**From:** [Craig Batchelor](#)  
**To:** [Danielle Petricevich](#)  
**Cc:** [CALEY, Helen](#); [PALMER, Brian](#)  
**Subject:** Allied Asphalt: Request for further information dated 28 February 2023 Geotechnical Matters  
**Date:** Thursday, 6 April 2023 2:00:00 pm  
**Attachments:** [Compiled ULS Results.pdf](#)

The Request for further information dated 28 February 2023 included the following on geotechnical matters:

**CPT file : CPT-05**

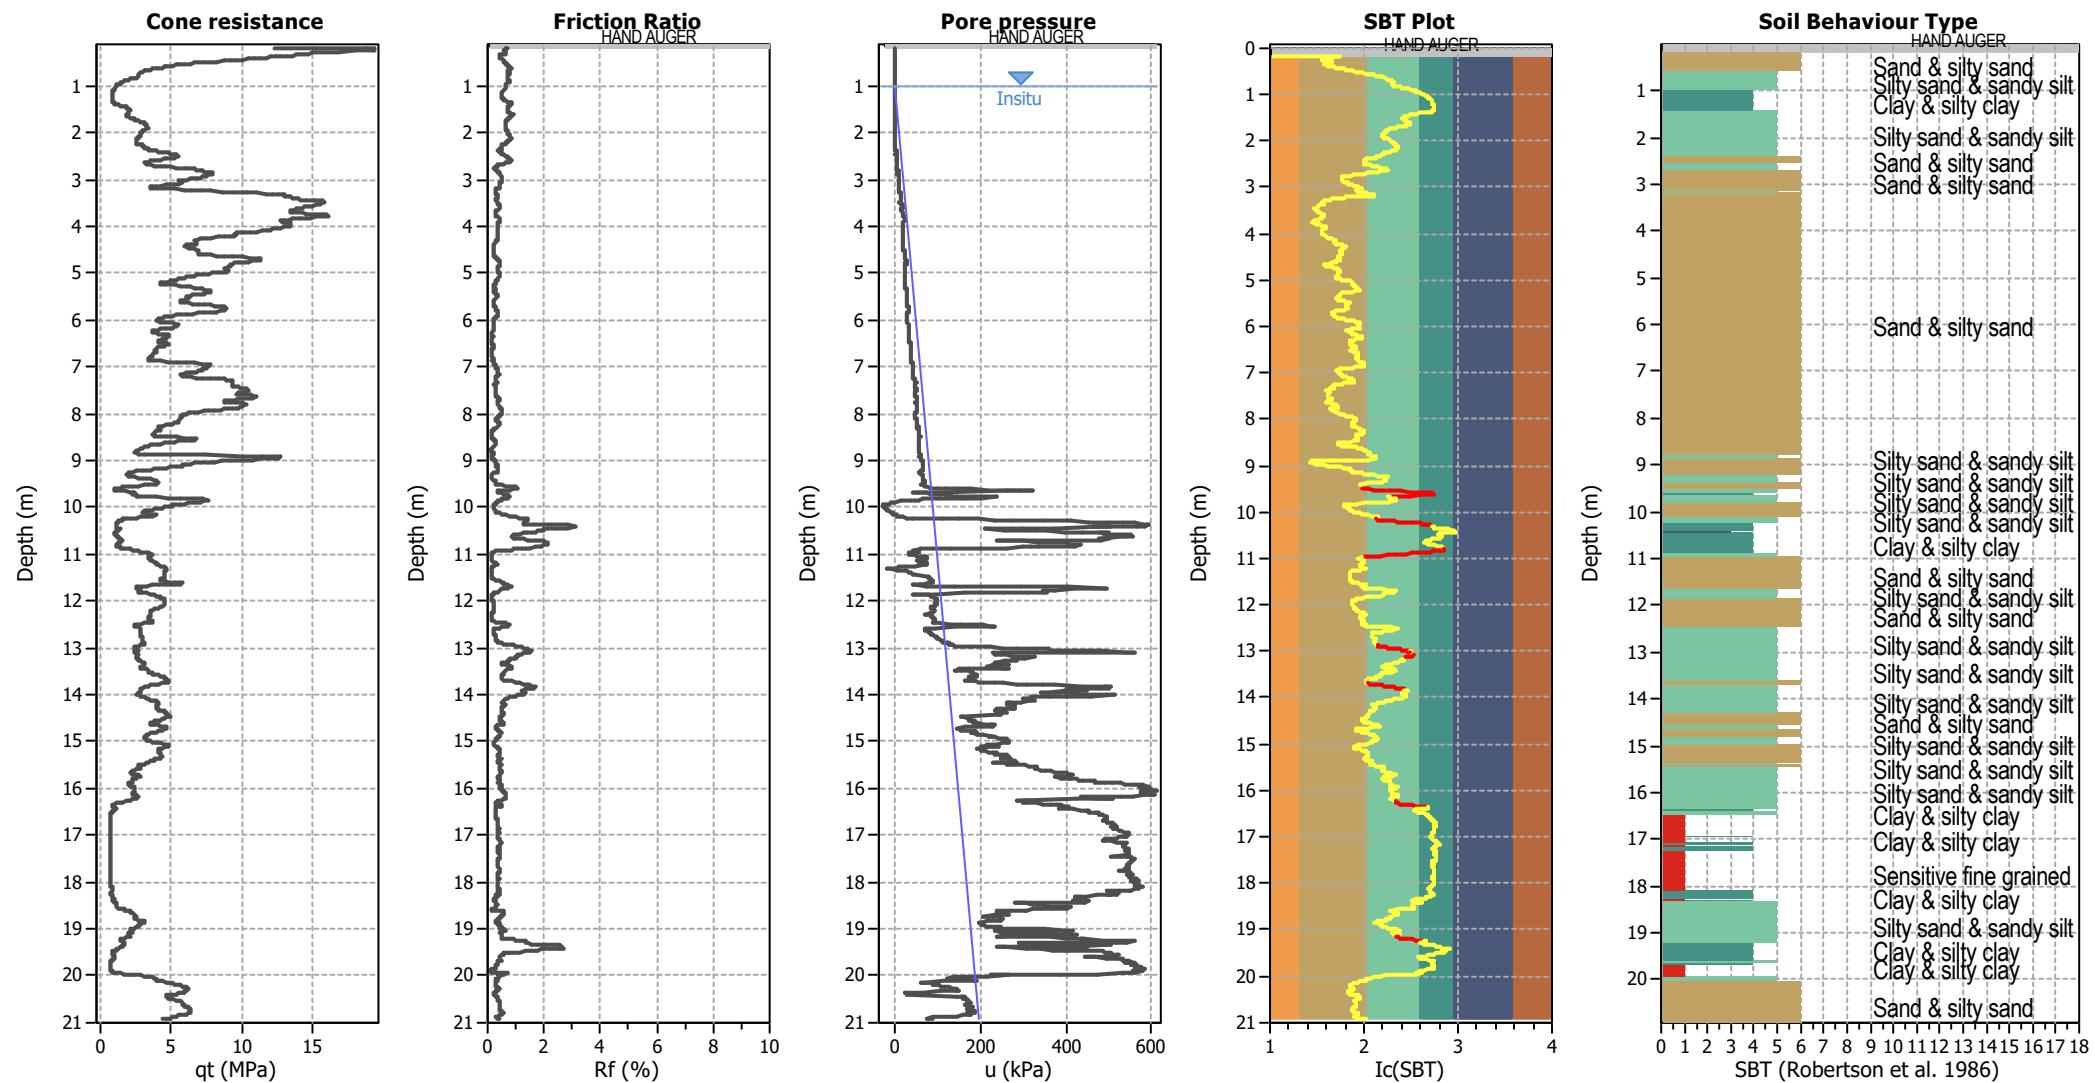
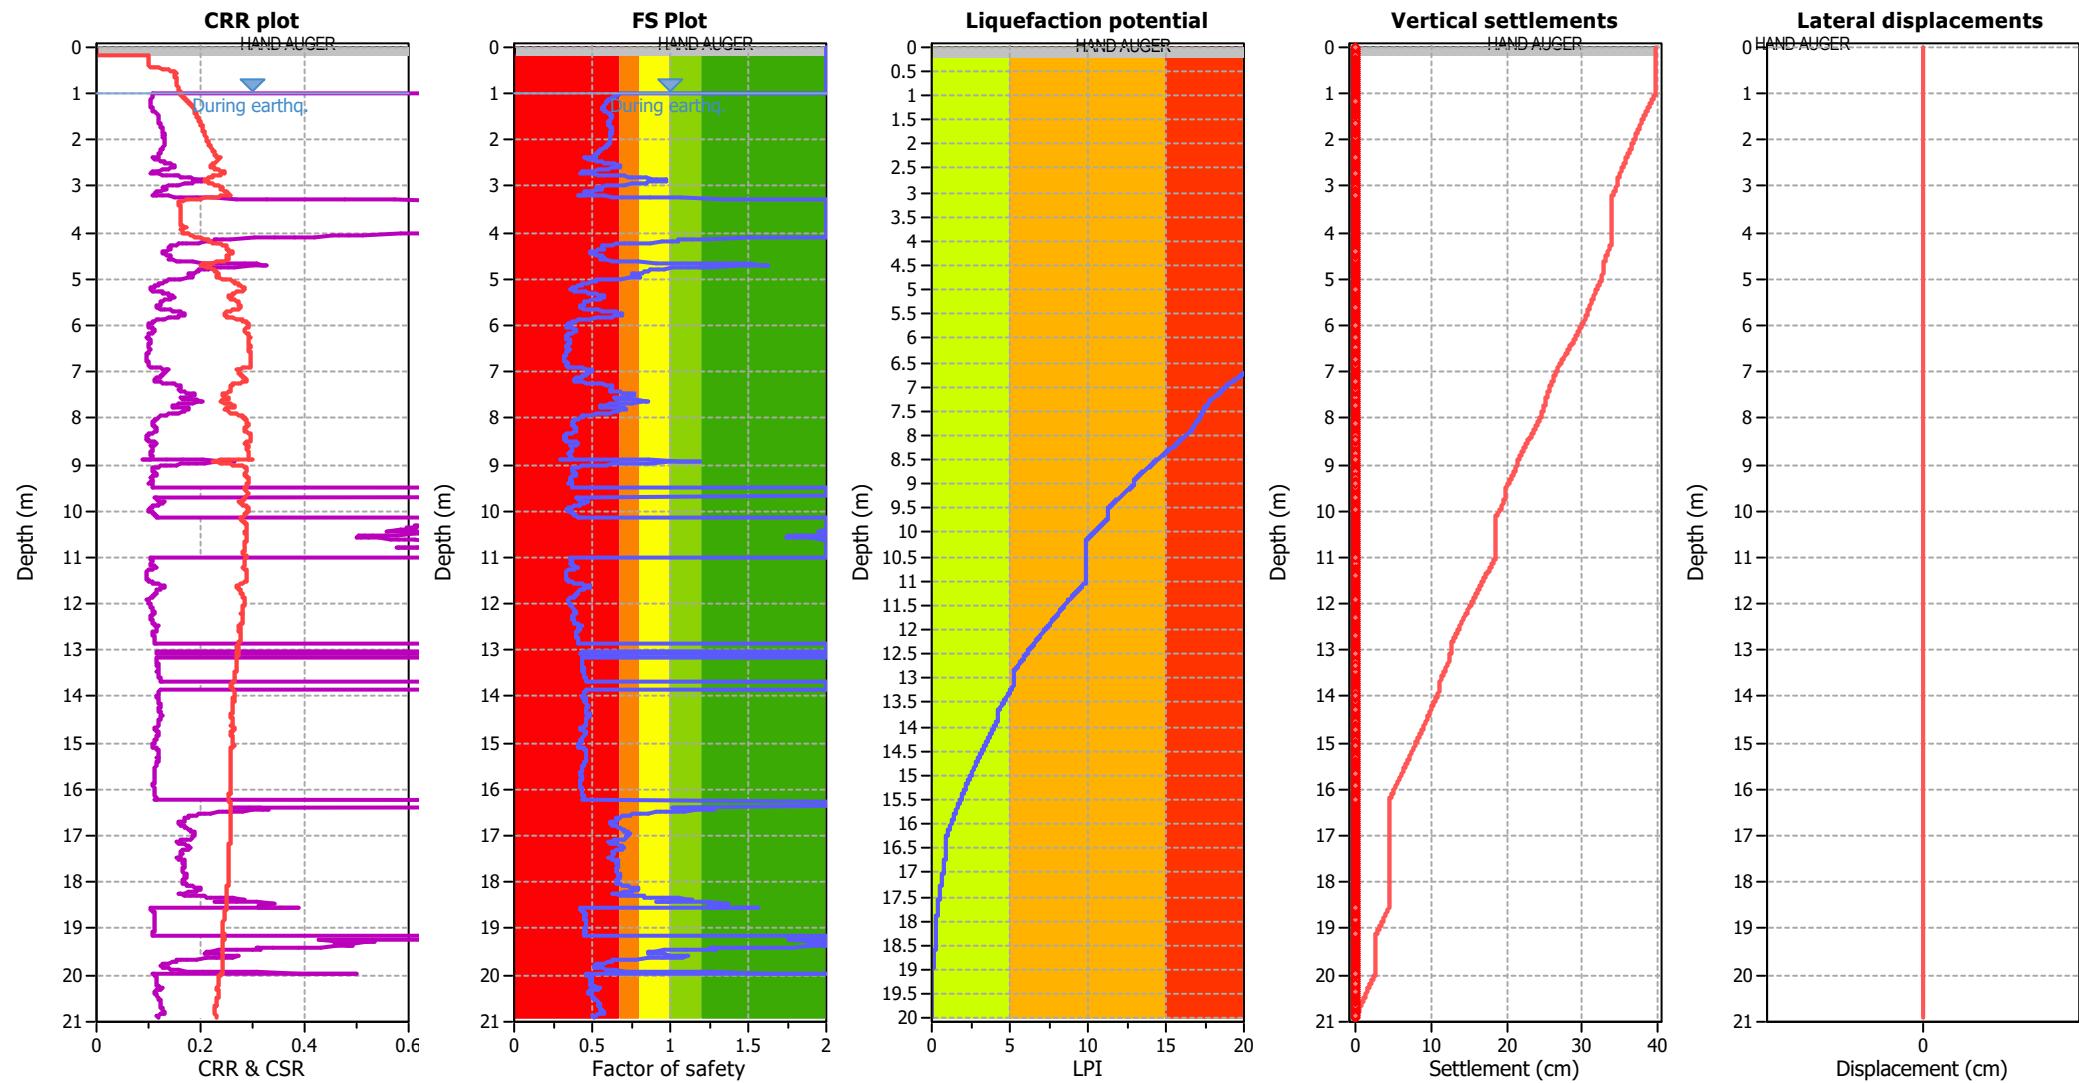
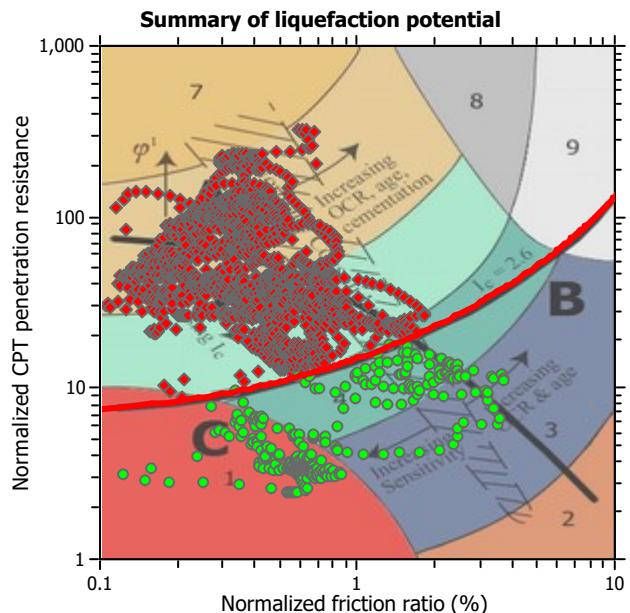
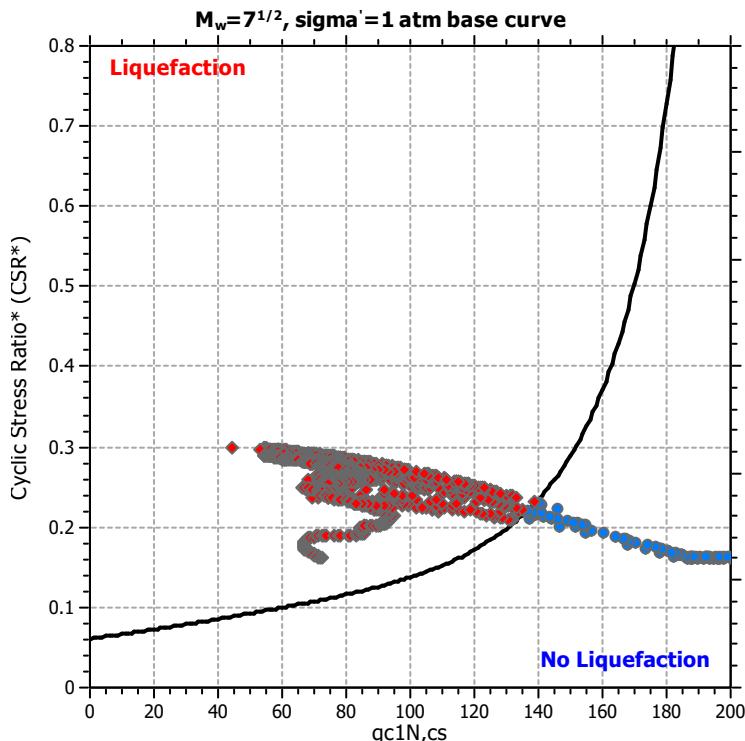
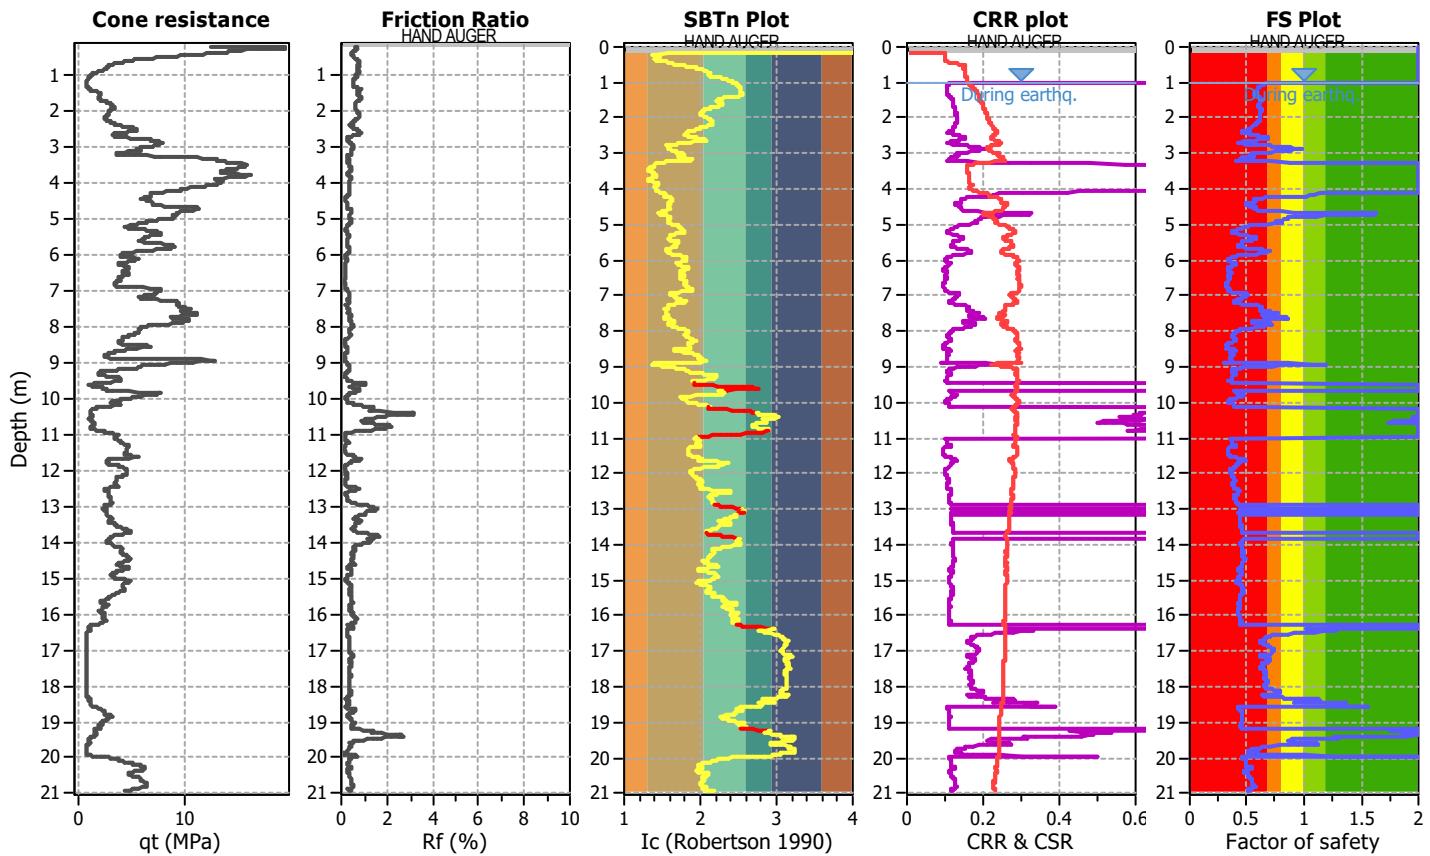
- a. Depth and magnitude of expected liquefaction under SLS and ULS conditions;*
- b. Approximate expected structural loads and required safe bearing capacity of soils;*
- c. Settlements as a result of the building loads;*
- d. Based on the above, the expected foundation type and ground remediation requirements for the asphalt plant;*
- e. Based on the above, the effect on neighbouring buildings/properties from the storage bins and construction works (ground remediation) for asphalt plant, if applicable, and assess mitigation options; and*
- f. Approximate revised earthworks volumes to include the expected areas and depths where shallow ground improvements are required."*

- a. Attached are example liquefaction result plots for the FH Mt Maunganui site. These are consistent with the stated hazard in the geotechnical assessment. These test results were not available at the time of the original assessment. The results use an estimated PGA that might change to suit the design requirements for the structures. The liquefaction predicted in the attached information may be over-estimated at depth. Good practice is to get lab testing samples to assess the plasticity of soils. This would be done as part of future design.
